ADDENDUM NO. 1A

Good Shepherd Catholic Church Community Center

July 27, 2026

GRC Project 21275

SHEET
M1.12

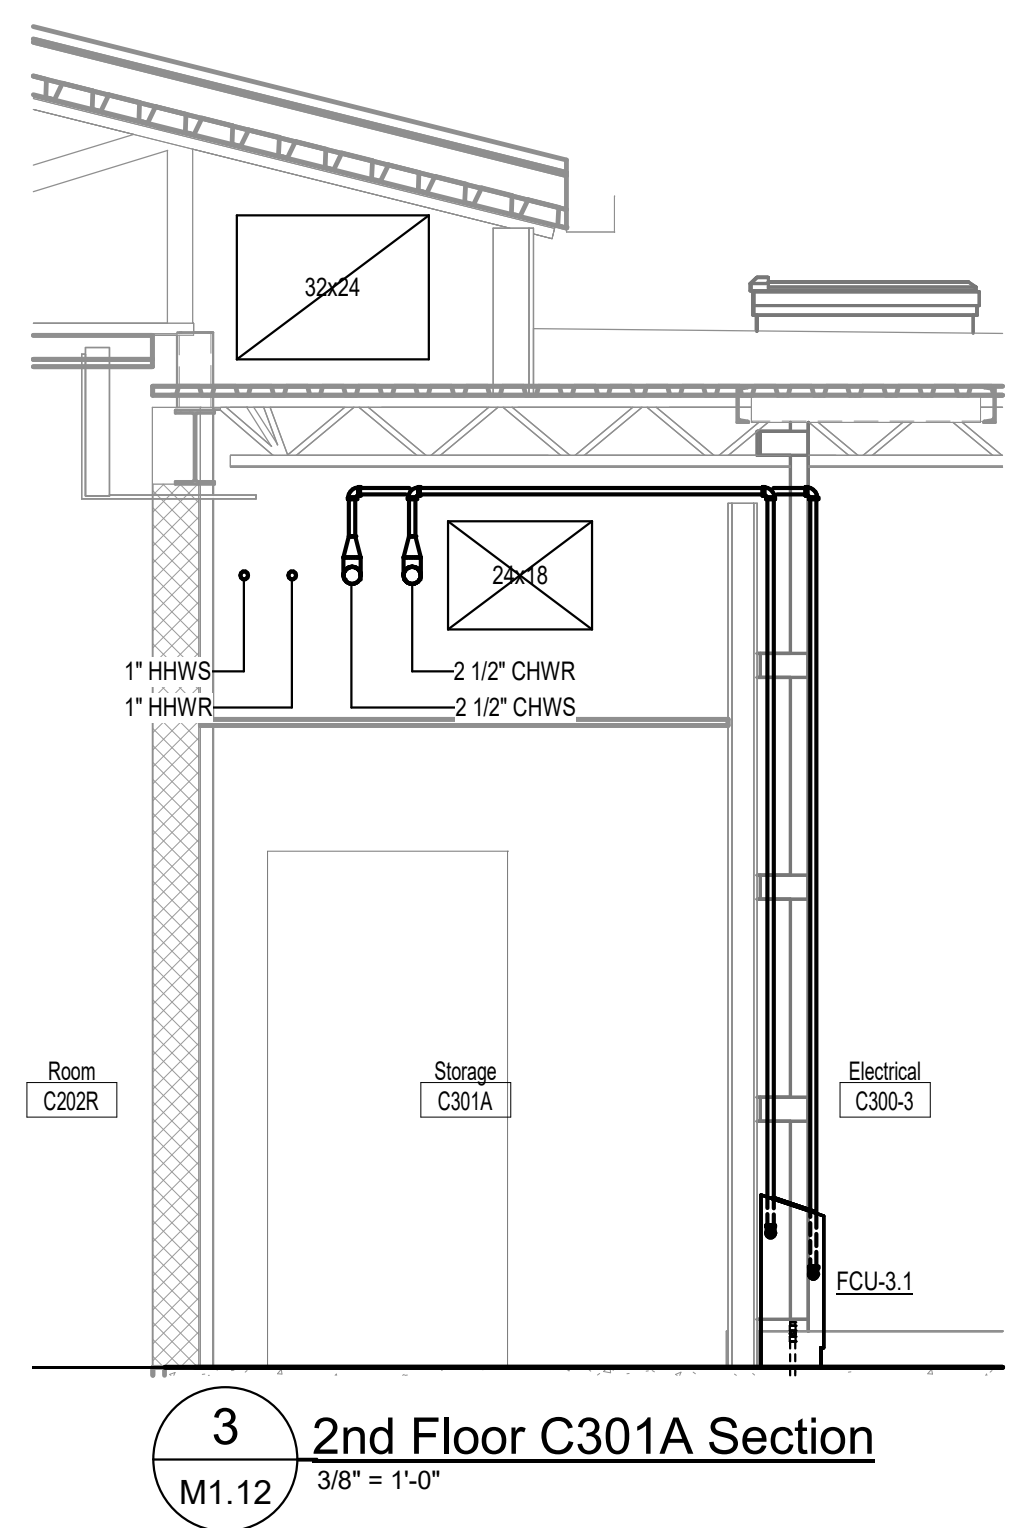
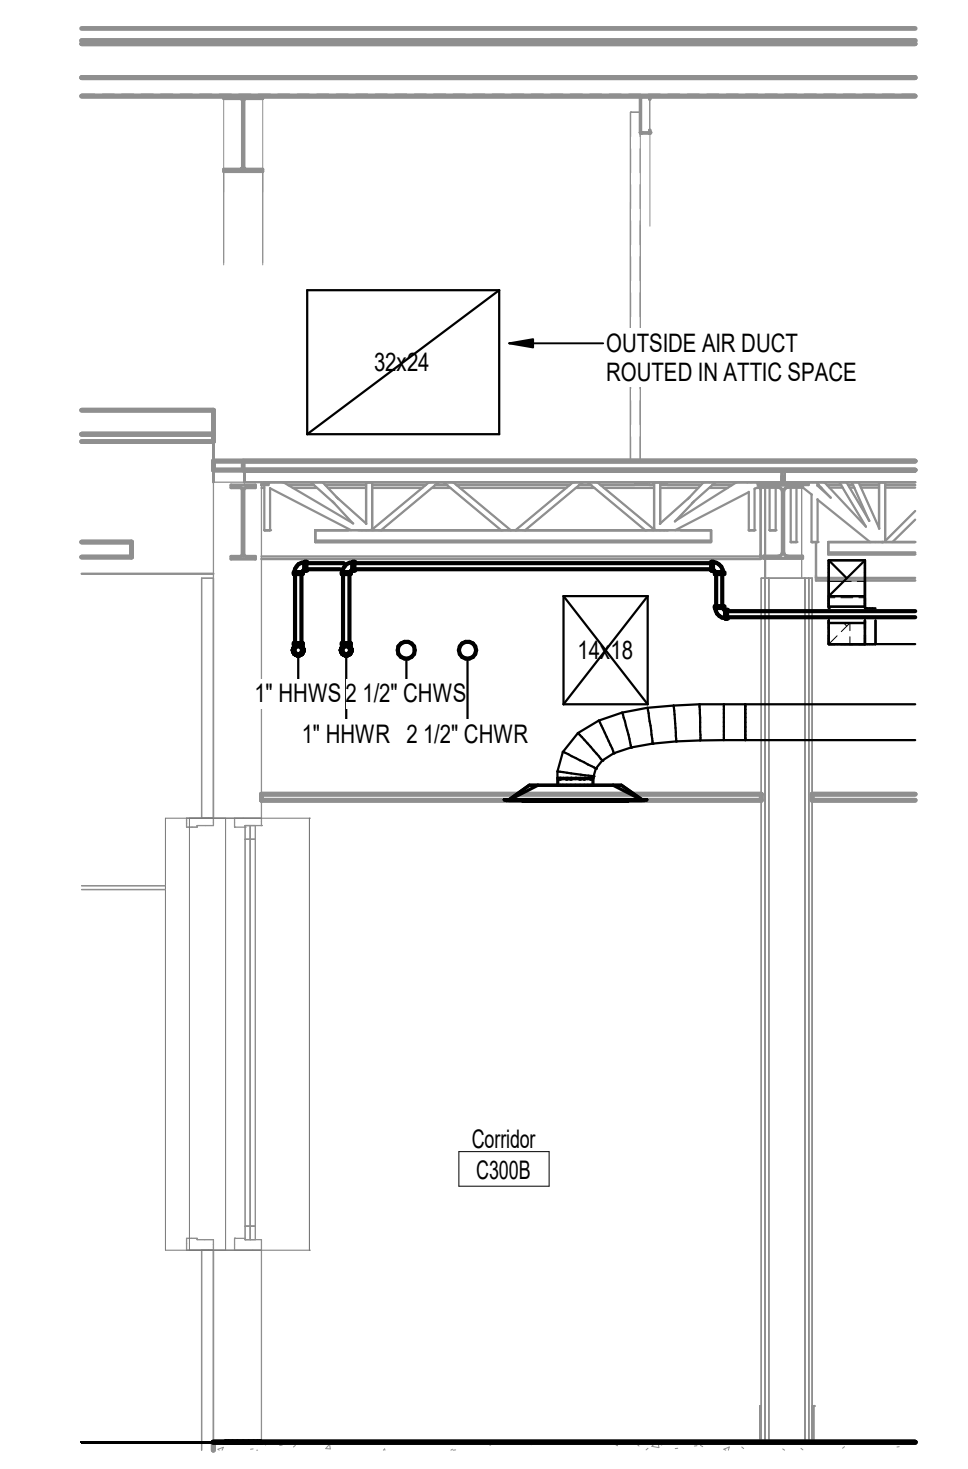
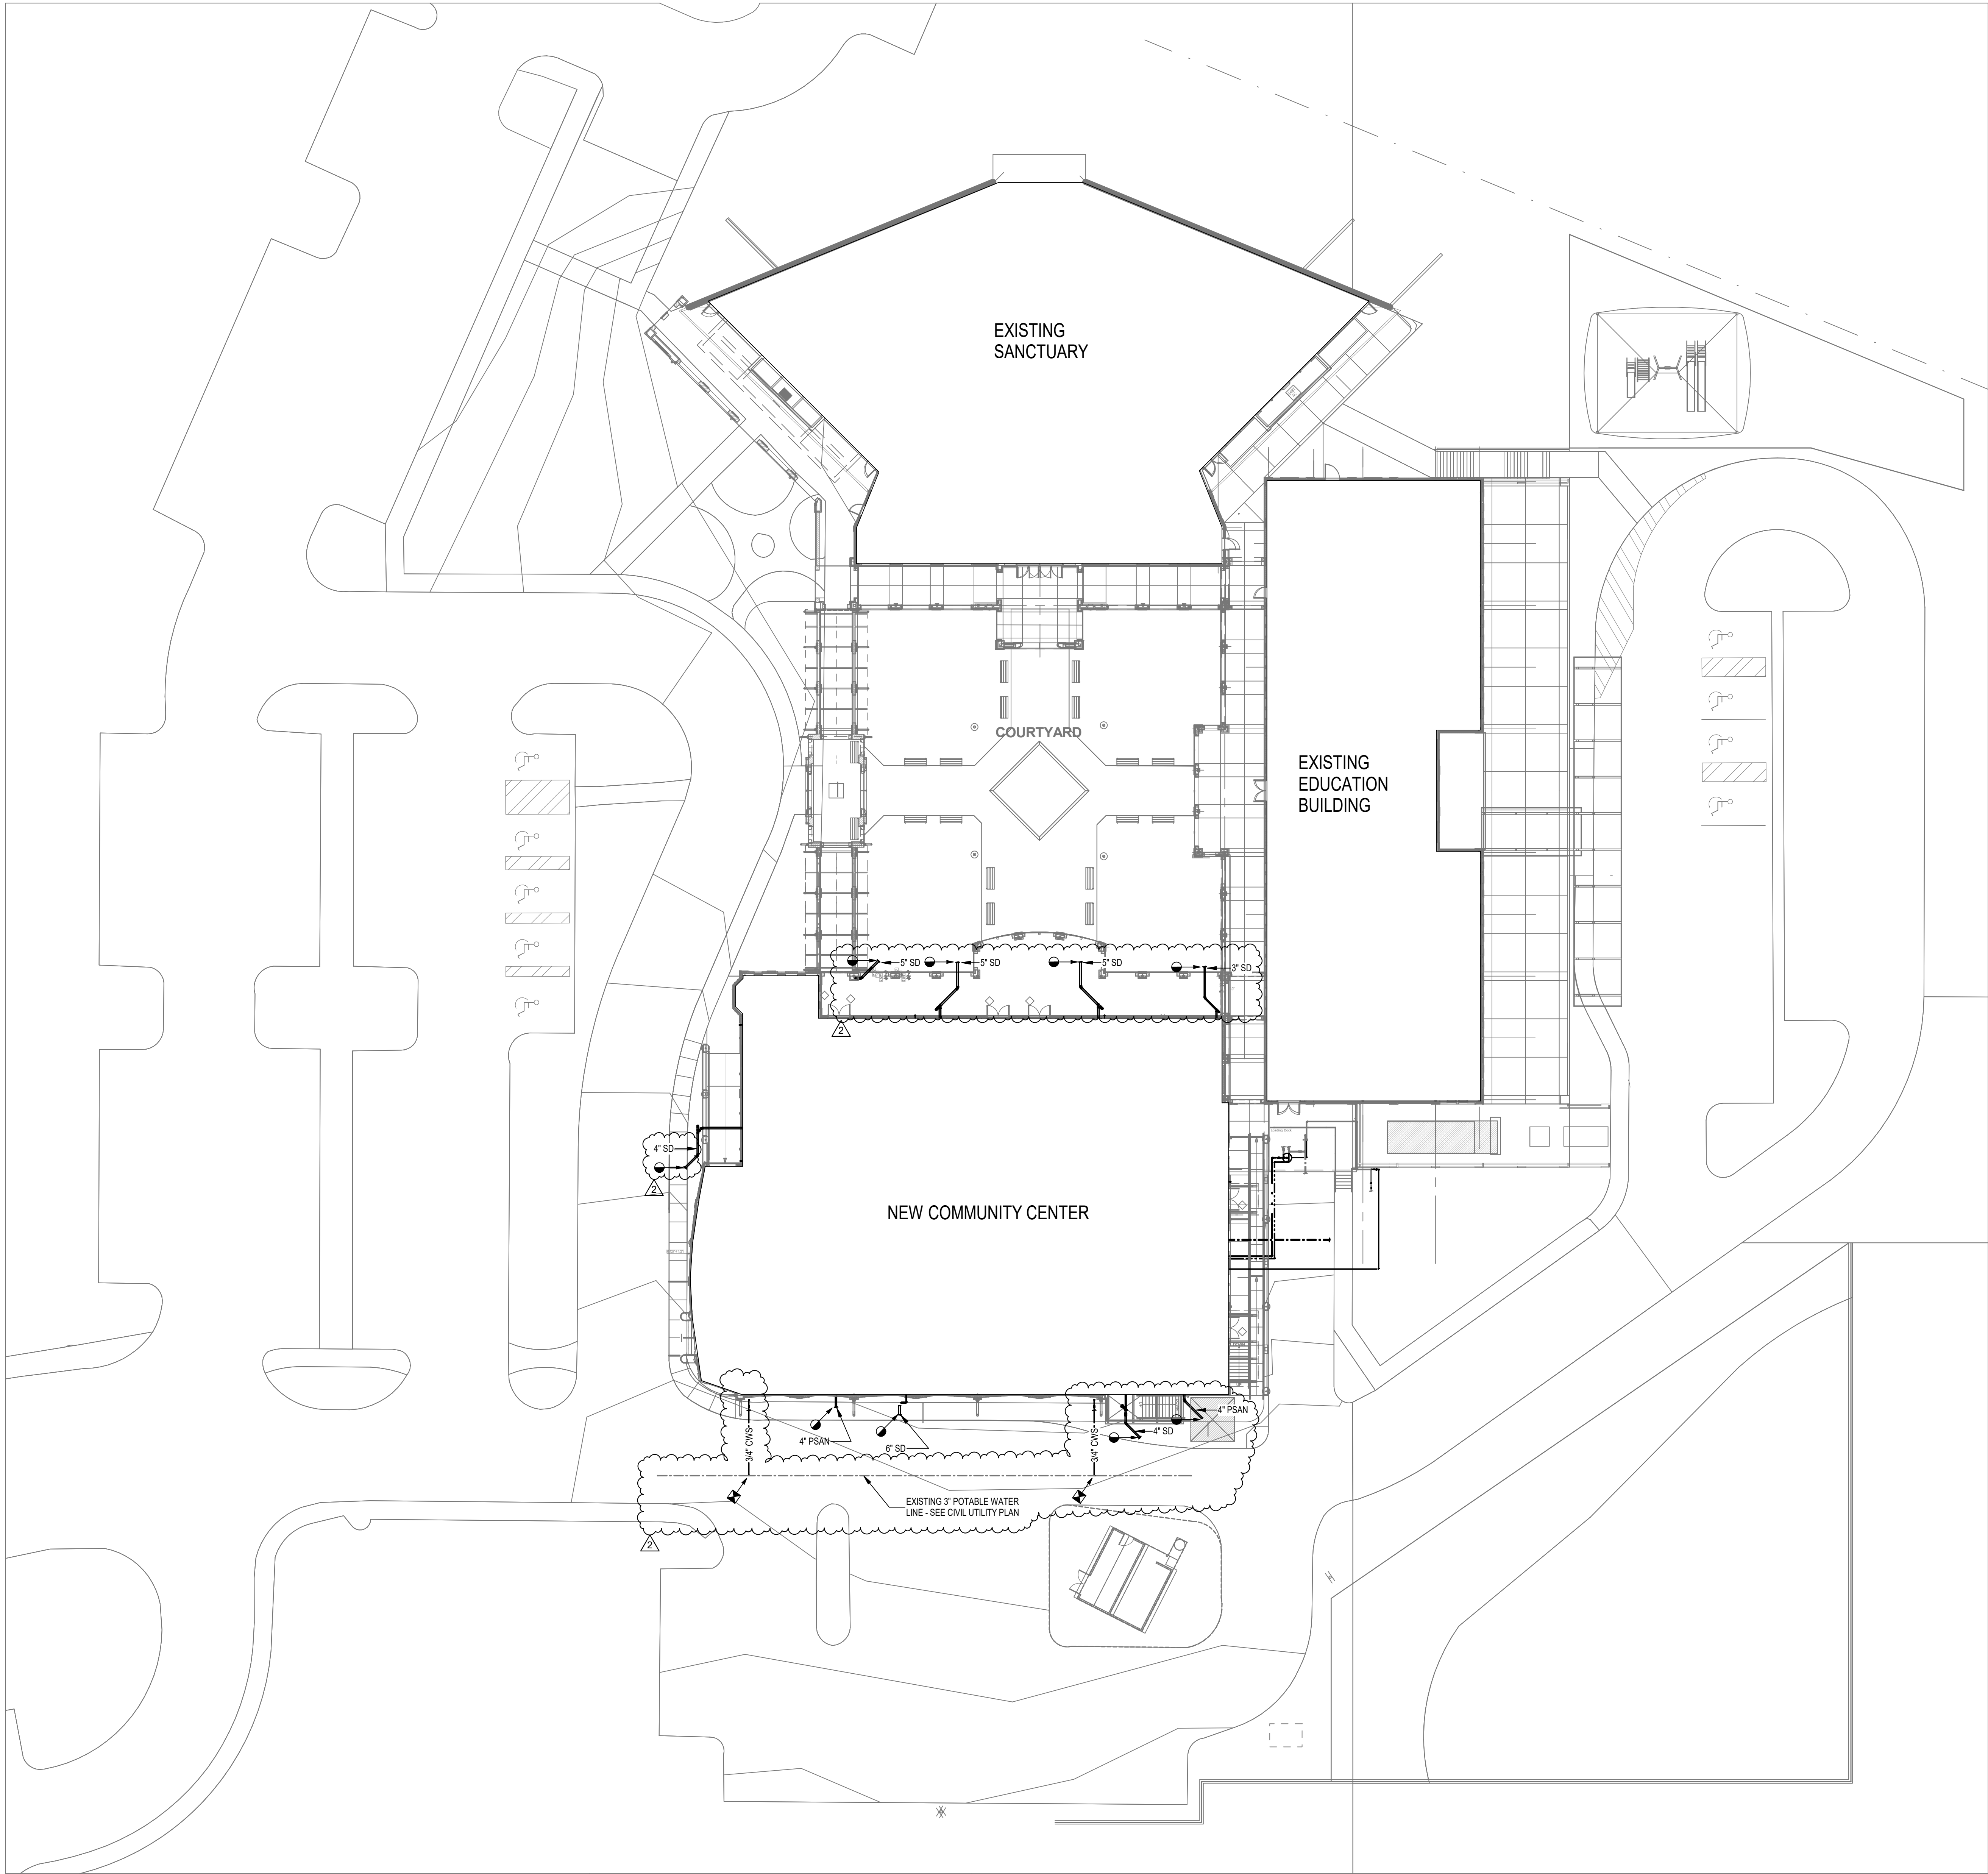
Item M1.1.2 **Revise** return air ductwork, in Men's Restroom C300-7.

DRAWING NAME
Site Plan

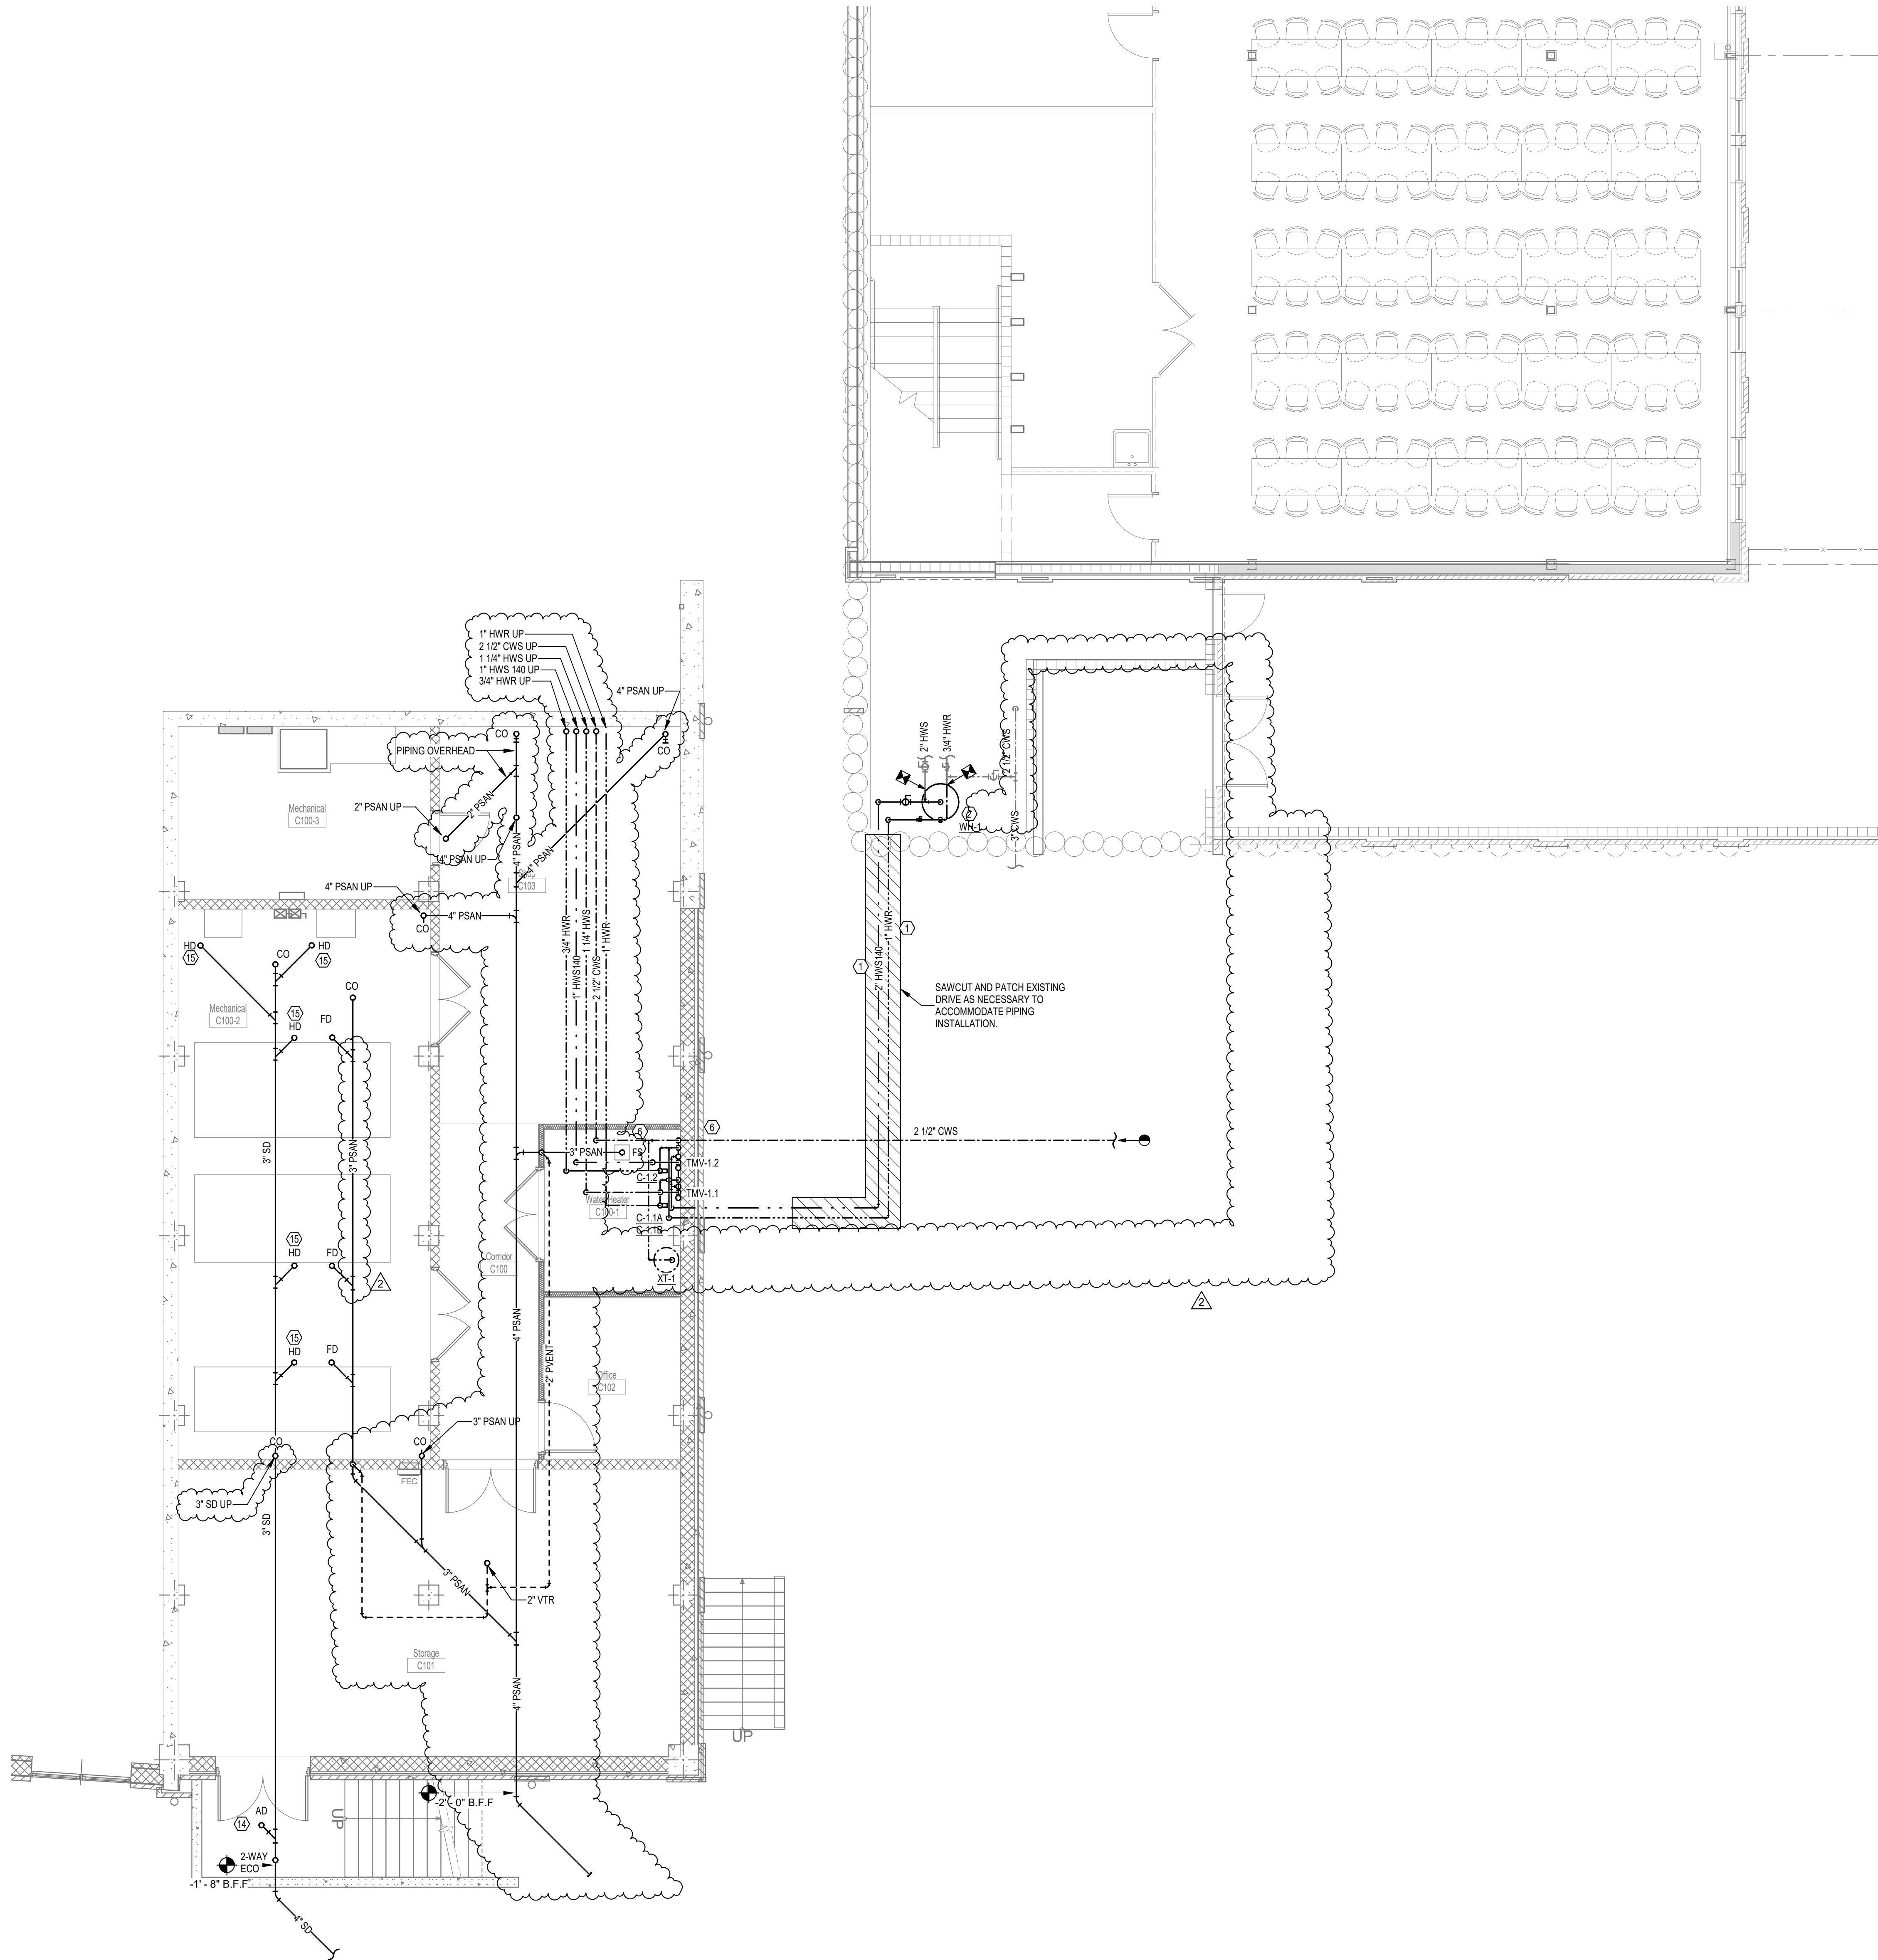
- Item P1.1.1 **Revise** civil tie in annotation locations to reflect the changes to the storm drain layout.
Revise domestic cold water supply civil tie in locations and relevant associated annotations.
